QER 12271

QER: POST-SALT 25KM FLGL SF301676C002.01+03- Zeta wires unlocking

Item	Traceability / identification
Project number	SF301676C002
Project name	POST-SALT 25KM FLGL
Pipe section	SF301676C002.01+03
ST number	ST10151958
Affected layer / equipment	Zeta Spiraling
Length affected	911.8m
Drawing number / MP code / STA / Dimension	Zeta wire 6.2 FI09 (MP 205)

Figure 1 : Zeta wire unlocked was detected at length 911.8m on the pipe.

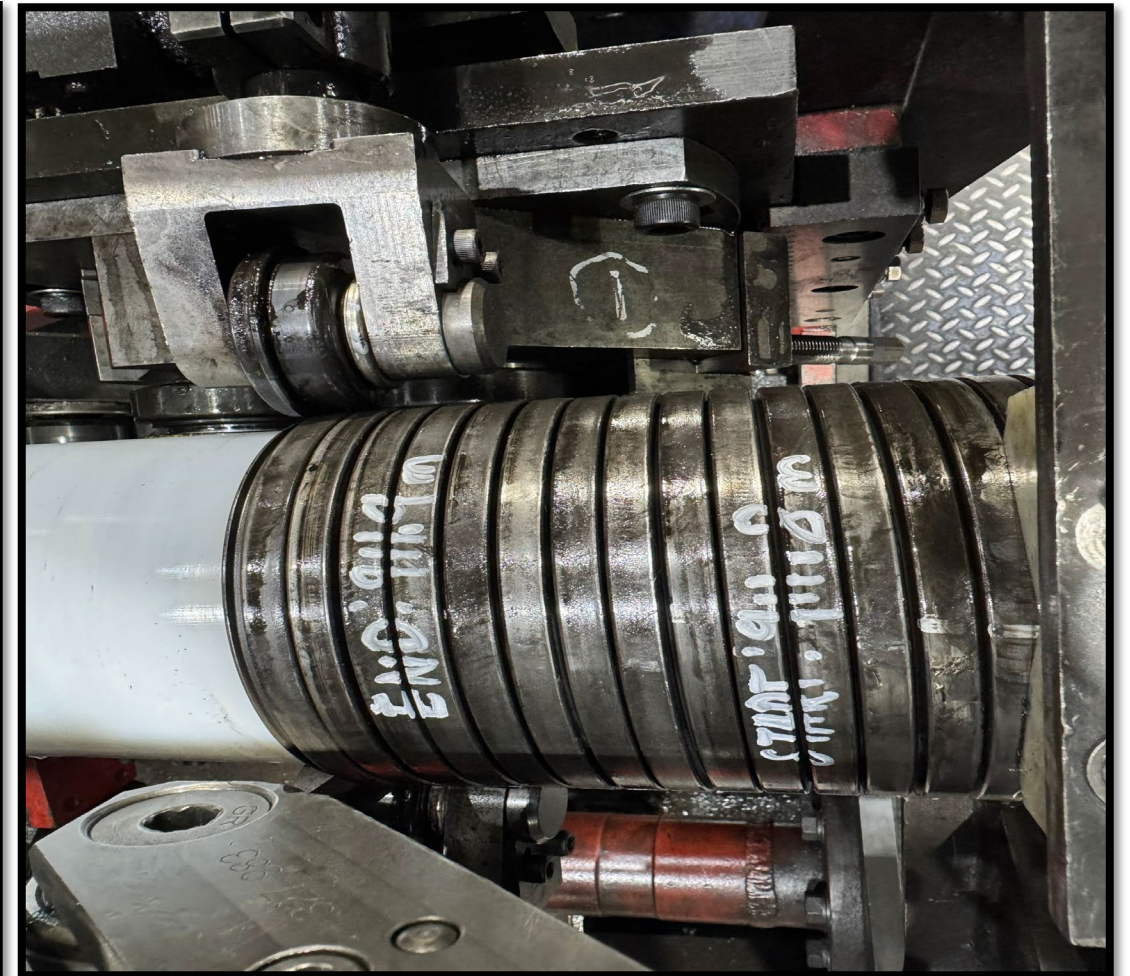
During the zeta spiraling of POST-SALT 25KM FLGL SF301676C002.01+03 (ST10151958), zeta wire unlocked was detected at length 911.8m on the pipe.

The root cause was due to wires entangled in bobbin #05 during running causing wire damage and wire unlock at laying point.
